Re: Oregon State Agency Comments on FERC's Draft Environmental Impact Statement for
Docket Nos. CP 17-494-000 and CP 17-495-000 (Jordan Cove Energy Project LP and
Pacific Connector Gas Pipeline LP)
DOJ File No.: 0ES456-ES456

Oregon State Agency Comments
Jordan Cove Energy and Pacific Connector Gas Pipeline Project
Draft Environmental Impact Statement
(Docket # CP17-494-000 and CP17-495-000)
July 3, 2019

Figure 3: Schematic of Ridgetop Right-of-Way

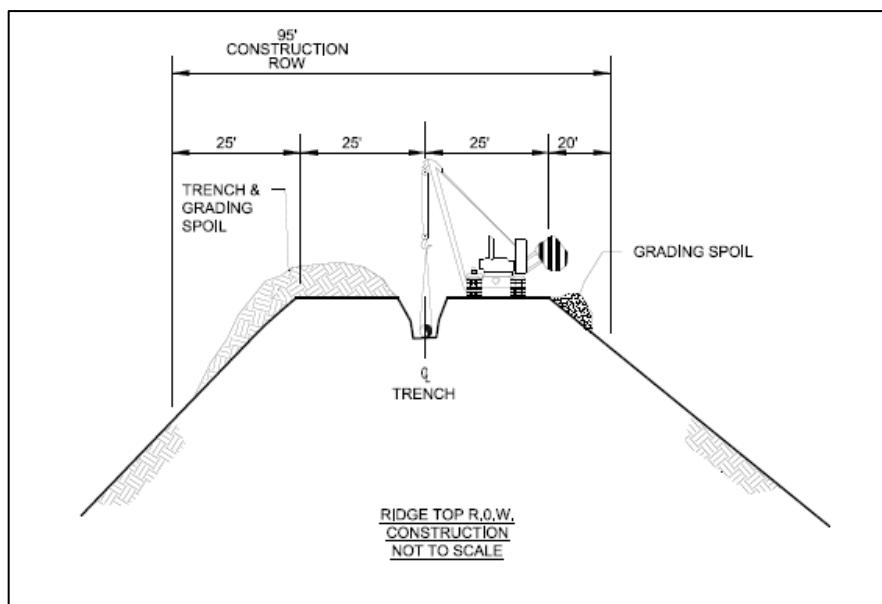
Although not delineated on JCEP's Environmental Alignment Sheets (Resource Report 1, Appendix H.1) or discussed in their Erosion Control and Revegetation Plan, typical drawings for right-of-way cross-sections in Resource Report 1 clearly show the use of a construction access road in the right-of-way. Without a durable surface, the soil in this corridor would experience compaction during the construction of the right-of-way, and during the trenching for pipe installation. The resulting soil compaction would increase runoff and, subsequently, erosion of native soils via rill and gully erosion without additional BMPs for the construction access road surface.

Figure 5: Spoil Placement on Headwalls for Construction ROW and TEWA 8.72-W between MP 8.56 – 8.75

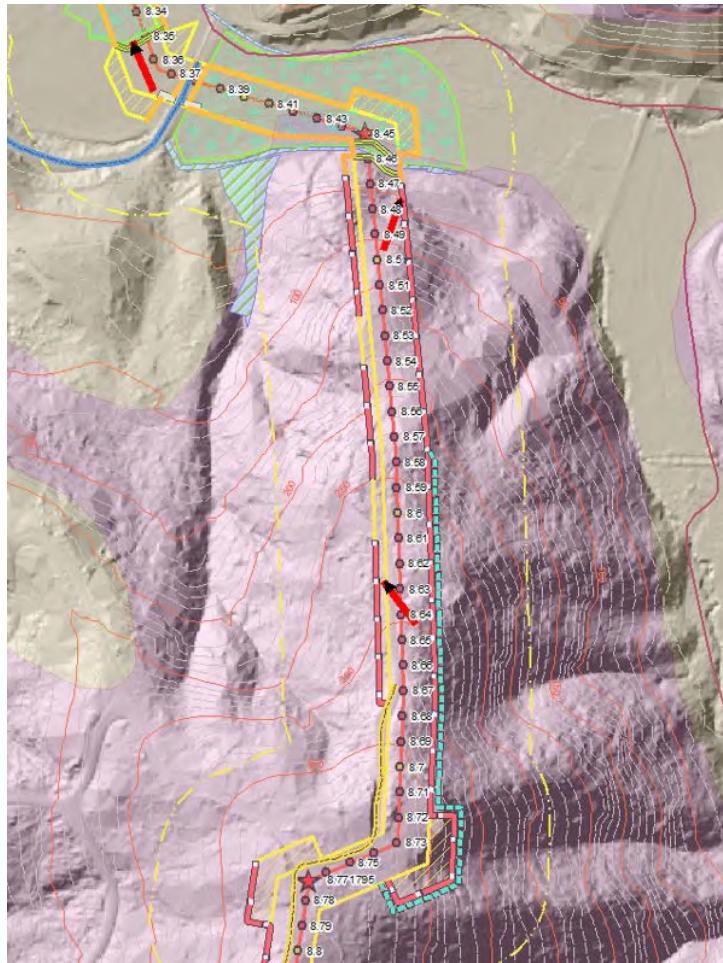
In the January 31, 2019 meeting to discuss the September 7, 2018 information request, JCEP presented a segment of the pipeline overlay on a Light Detection and Ranging Map (see Figure 5). This LiDAR map segment clearly shows the working side of the construction ROW with its construction access road and Temporary Extra Work Area above three headwalls (i.e., unstable slopes). As discussed above, these areas would support trenching and grading spoils and may require fill to level this working surface. The weight of the fill and/or trench and grading spoils, the anticipated traffic loads, and the stored material in combination with additional runoff due to the lack of a forest canopy present a substantial water quality risk to streams as well as a risk to worker and public safety.

Given the proposed placement of trench and grading spoils and, potentially, fill placed on the rapidly moving landslide risk area from Pipeline Milepost 8.56 to 8.75 (see Figure 5), DEQ reviewed Table B-3a in Resource Report 6 as a quality assurance check on JCEP's Phase I landslide hazard evaluation. Table B-3a summarizes the sites investigated in JCEP's Phase II field reconnaissance. In its review of this table, DEQ determined that JCEP did not include the area from between Milepost 8.56 to 8.75 in its field data collection and risk assessment. JCEP also did not conduct a surface reconnaissance for the areas of concern featured in Figures 6 and 7. Given this, DEQ referenced the methodology for identifying moderate and high rapidly moving landslide (RML) risks in Resource Report 6 as described below.

Figure 8: Map of Hudson Creek-North Fork Coquille Subwatershed

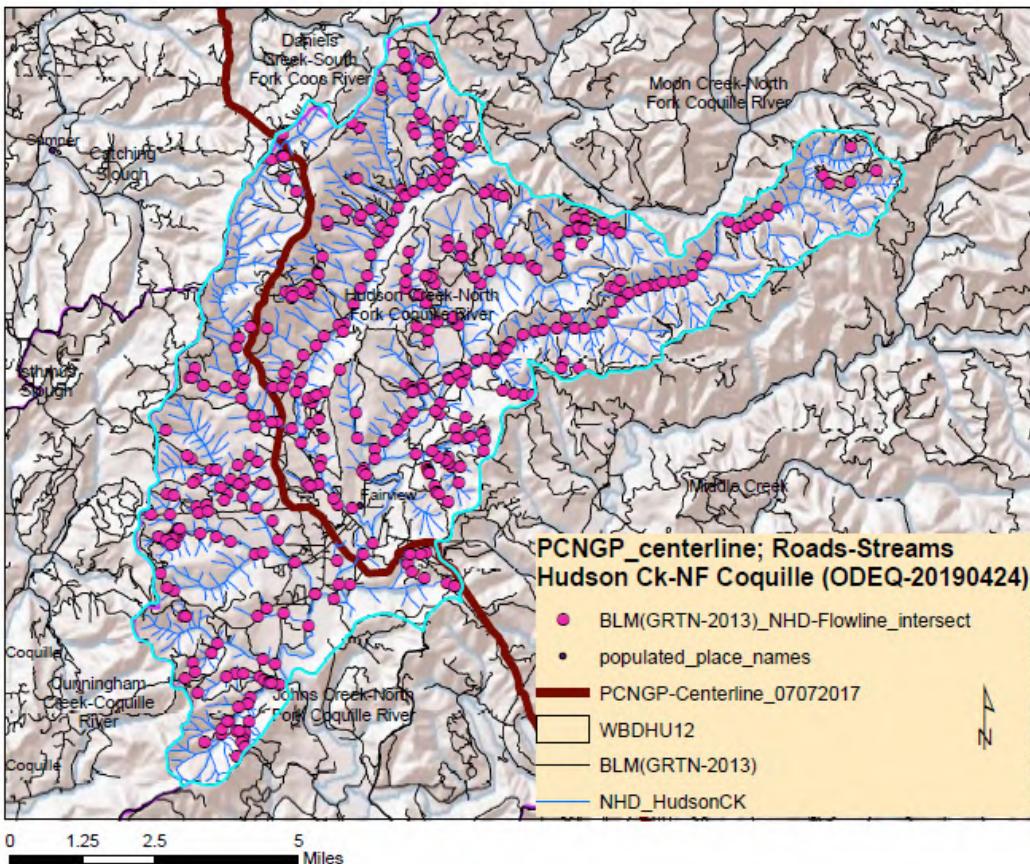
As a sample of road-stream intersections in the highly dissected drainage basins of the Coast and Cascade Ranges, Figure 8 shows the number of BLM road-stream crossings in just one of numerous subwatersheds where the construction ROW is located. This map does not include cross drains for roads that are also within 200 feet of a stream and, therefore, hydrologically connected to this stream. If a field inventory included cross drains, the number of road-stream interactions on this map would be greater than currently displayed in Figure 8. Many of the BLM roads depicted in the map below would serve as an existing access road for pipeline construction. Given this small area, JCEP's estimate of 21 existing access roads that could potentially deliver sediment is a significant underestimation.

Figure 9: Construction Right-of-Way Above Headwall

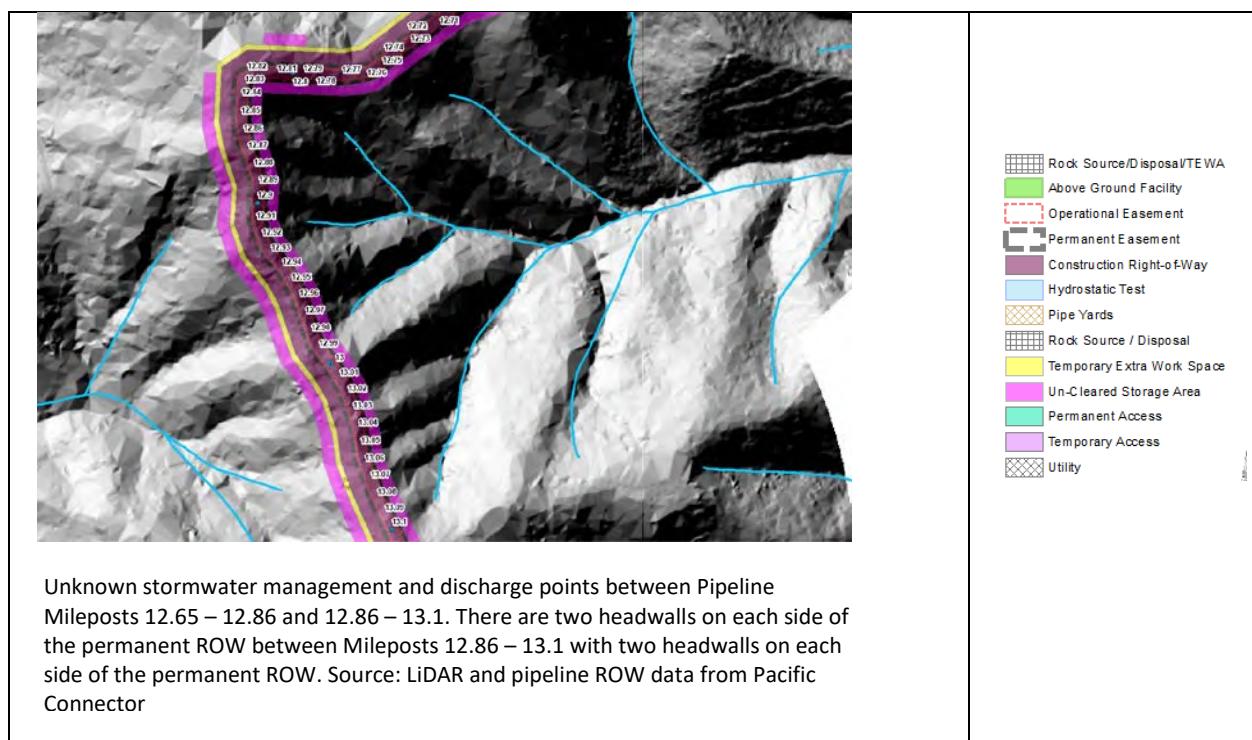
To ensure compliance with statewide narrative criteria OAR 340-041-0007(1), DEQ developed the *Section 401 Water Quality Certification Post-Construction Stormwater Management Plan Submission Guidelines* (March 2018). In Section E.2.2 of these plan submission guidelines, DEQ requests that project proponents determine if infiltration of stormwater discharge should be avoided due to steep slopes or landslide risks (see Page 9). The proposed permanent ROW traverses over and along unstable slopes in numerous locations. For example, Figure 9 below shows sections of the permanent ROW above headwalls. JCEP has not provided DEQ with a post-construction stormwater plan for the permanent ROW demonstrating how JCEP would manage stormwater along the permanent ROW and, in particular, along landslide susceptibility zones. As discussed in Section 6.1.2.1 of this Evaluation and Findings Report, the stormwater discharge from slope breakers can reduce slope stability.

Figure 10: Pipeline Parallel to and Crossing Spencer Creek and crossing Clover Creek, near Milepost 177

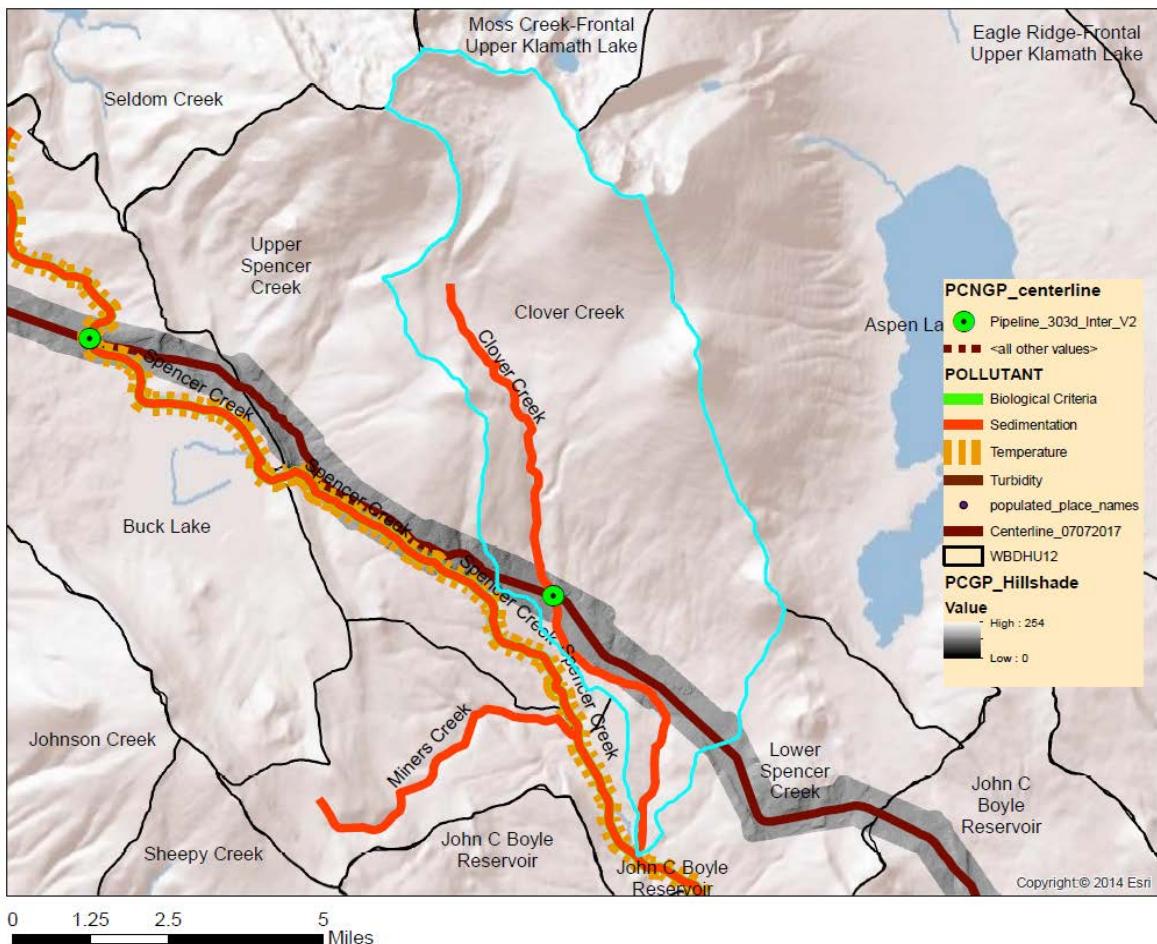
Figure 10 shows one of several examples of the permanent ROW crossing or paralleling streams on the 303(d) list for sediment or crossing streams discharging to these sediment-listed streams. Based on its proposed conceptual approach for operating the ROW, the permanent ROW has the potential to discharge sediment at stream crossings. Ongoing increases in sediment loading to a waterbody that is listed on the 303(d) list for sediment in not allowed without either a TMDL allocation, or an implementation plan showing that there will be no increase in loading. OAR 340-41-0004(7)(“Water quality limited waters may not be further degraded except in accordance with paragraphs (9)(a)(B), (C) and (D) of this rule.”⁶⁵JCEP has not provided the analyses for the discharges that would

For example, given the proposed pipeline route, Figure 10 shows the potential for the loss of effective shade from the construction right-of-way as the pipeline parallels Spencer Creek near Milepost 177. Spencer Creek is listed as impaired for temperature. JCEP informed DEQ that the riparian impacts from TEWAs and impacts from FERC's 15-feet buffer requirement, noted above, were not included in the 2017 Thermal Impact Assessment. DEQ requested that JCEP include these impacts in a revised assessment. To-date, JCEP has not provided this revision.

Figure 10 shows the potential for the loss of effective shade from the permanent right-of-way as the pipeline parallels Spencer Creek near Milepost 177. DEQ listed Spencer Creek as impaired for temperature. JCEP informed DEQ that the riparian impacts from FERC's 15-feet buffer requirement, noted above, were not included in the 2017 Thermal Impact Assessment. DEQ requested that JCEP include these impacts in their assessment and provide a revised assessment.

Figure 11: Potential Dredge Disposal Areas Relative to LNG Terminal and Adjacent Wetlands

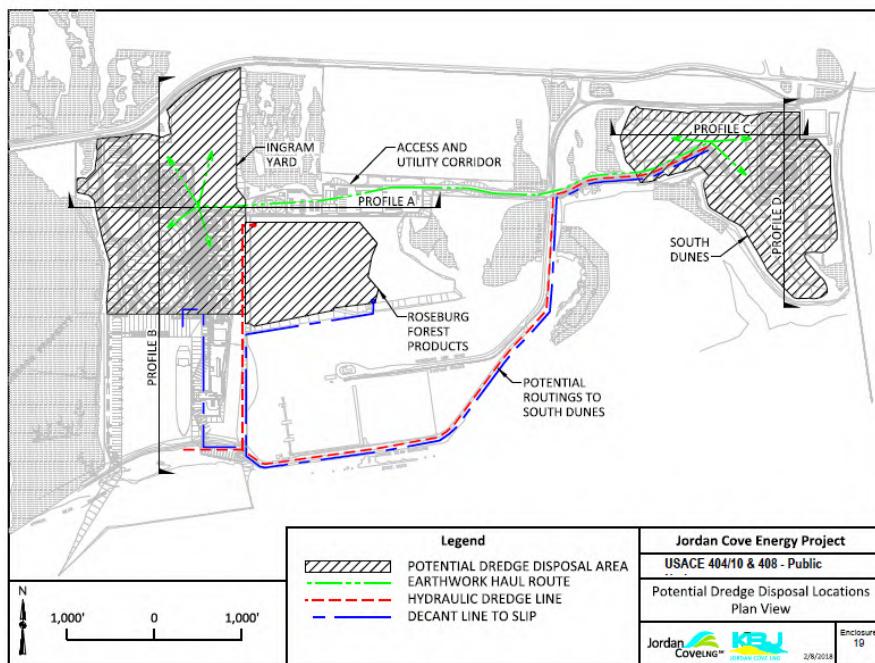
In its October 8, 2018 response to DEQ's September 7, 2018 information request, JCEP referred DEQ to Potential Dredge Disposal Locations featured in Enclosures 19 – 22 of Part 1, Appendix N-5 of the 401 Water Quality Package. DEQ presents Enclosure 19 below to highlight the lack of detailed practices to manage the wetlands – shaded gray – adjacent to proposed dredging disposal areas:

Enclosure 19 does not show structural controls to demonstrate saline leachate or decant from dredged material would not discharge to adjacent freshwater wetlands. JCEP has not indicated how it would place containment

Figure 12: Proposed Finish Grade of Dredge Soil Locations

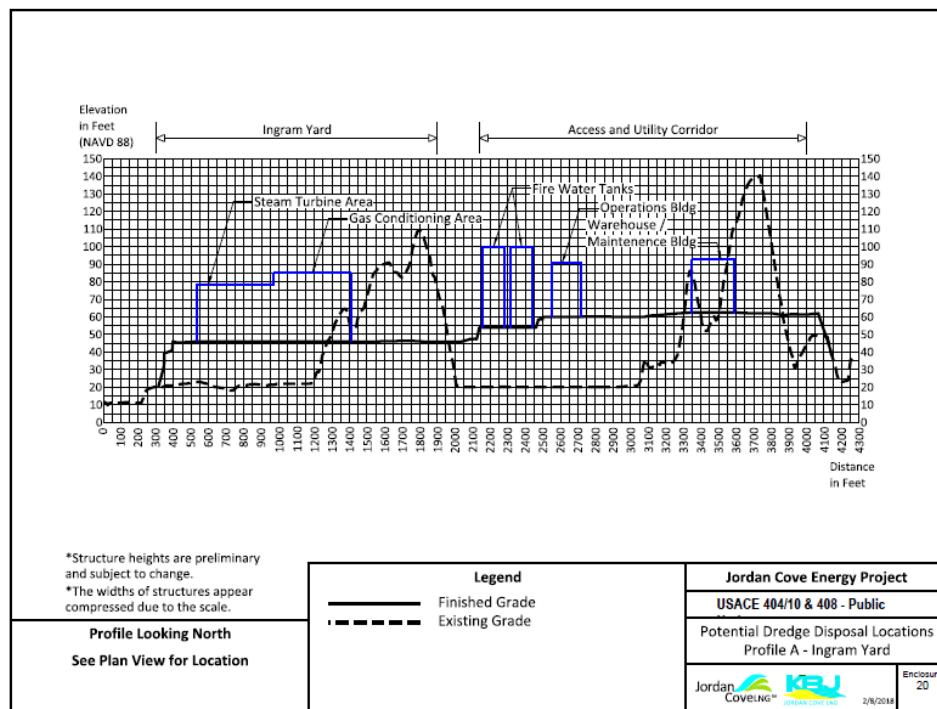
structures around the dredged material nor change the grade to direct decant to the dredge line, size a collection basin to capture the decant, operate a pump to transfer the decant to a discharge location, or propose a discharge location. Enclosures 20 – 22 only provide the elevation of dredge material as shown in Figure 12.

Figure 13: Lick Creek and Little Butte Creek Vicinity

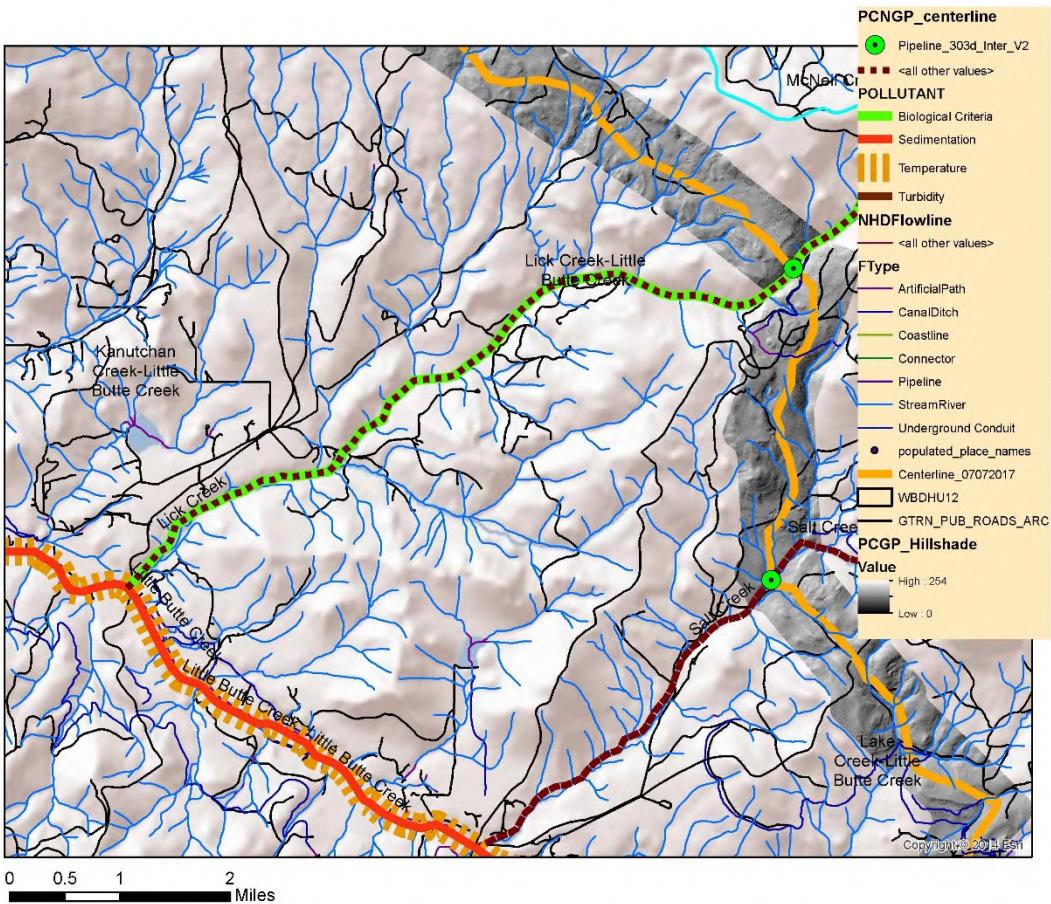
Figure 13 shows the JCEP Gas Pipeline crossing tributaries to Lick Creek and crossing Lick Creek near Milepost 140.27. Lick Creek is listed on the 303(d) List for biocriteria. Sediment discharge from pipeline construction and debris flows from landslides initiated by the construction of the right-of-way could affect aquatic life in Lick Creek and the attainment of the biocriteria standard in this impaired waterbody. As noted earlier in this report, for a 303(d) listed waterbody, without a TMDL, no ongoing detrimental impact is authorized. Although natural landslides are an integral part of stream form and function, human-caused debris torrents and sedimentation impact water quality by changing the natural cycles of sediment delivery to systems, which impacts the aquatic environment; thus, affecting aquatic life (Castro and Reckendorf 1995).

Figure 15: Pipeline Crossing at Wetland S1-04 (Willanch Slough) showing no “neckdown” of the ROW

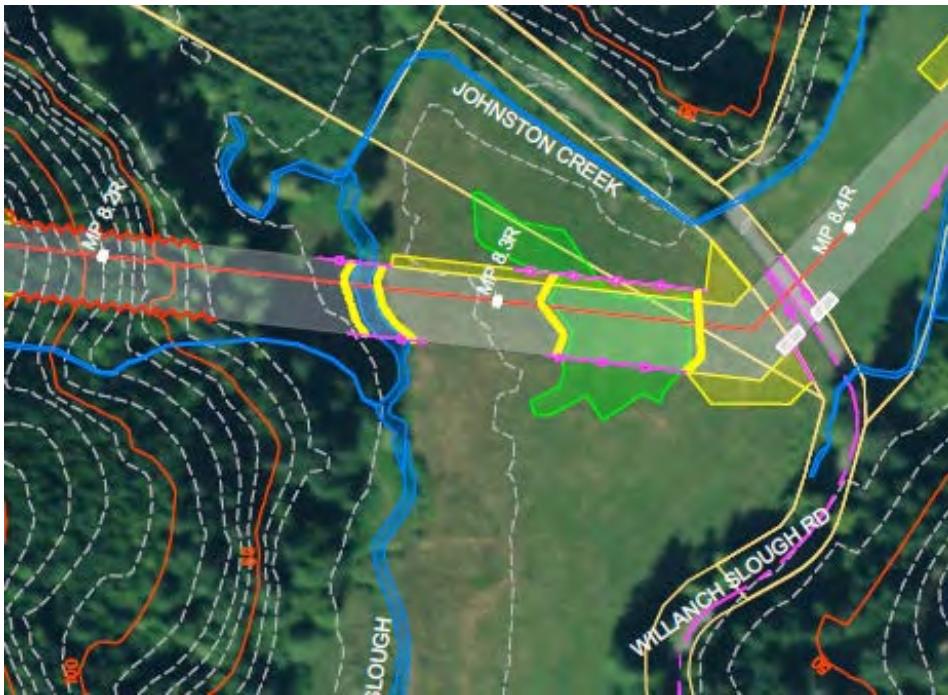
As an illustration of the reasons for DEQ's concerns about the temperature impacts of the proposed Project, at pipeline stream crossing at Milepost 58.78, Ollala Creek is limited for temperature year round and is under an approved TMDL. Similarly, DEQ has placed Rice Creek (Milepost 65.76), South Umpqua River (Milepost 71.27), North Myrtle Creek (Milepost 79.12), South Myrtle Creek (Milepost 81.19), and many others on the 303(d) list for temperature. These streams are under an approved temperature TMDL.

Figure 17: Modeled Turbidity from Capital and Maintenance Dredging at NRI-3

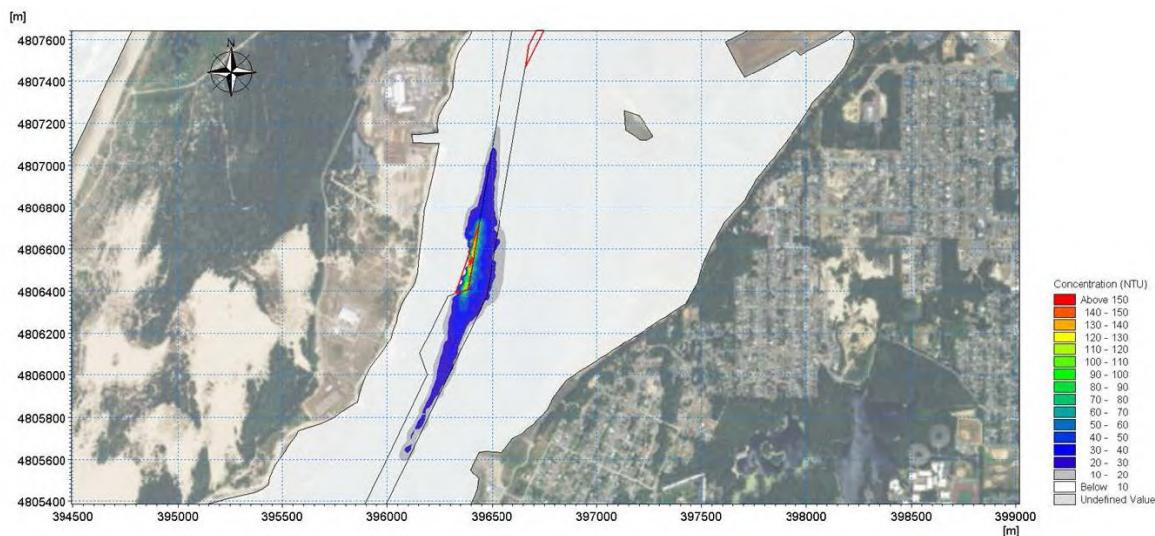
In addition, JCEP modeled the effects of turbidity at each of the proposed dredging locations using clamshell, hydraulic suction dredging, and excavation methods.⁹⁴ The modeling confirmed turbidity exceeding 10 NTU above background levels extending a total of more than one mile above and below the Navigational Reliability Improvement dredge locations. The modeling also confirmed elevated but comparatively localized turbidity plumes at the Slip, Access Channel, and eelgrass mitigation dredge locations. The report recommends that both capital and maintenance dredging operations incorporate construction BMPs, although the "nature and extent of BMPs should be determined through coordination with the regulatory agencies".
